HOUSTON
HOUSING AUTHORITY

The Houston Housing Authority ("HHA"), has issued this Amendment No. 1 to IFB 23-40 HVAC Material Supply and Deliver to Multiple HHA Properties for the purpose of:

12,000 BTU WiFi Window Room Air Conditioner (E-Star)

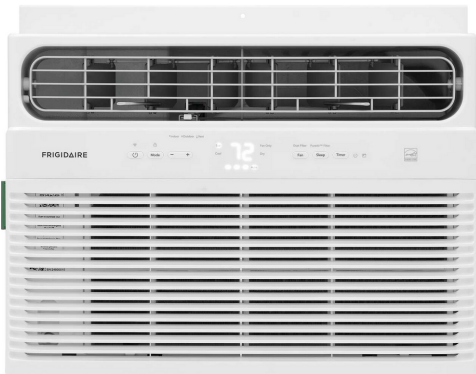
Question 9: There are two different models for consideration for bidding as equivalents. Please review and advise if one or both would be acceptable equivalents on the attached spec sheets for Frigidaire Window AC Models: FHWW124QWD1 & GHWQ123WC. See Attachments for Specifications Equivalents.

Answer 9: This is acceptable. Please see revised Supplemental Price Sheet.
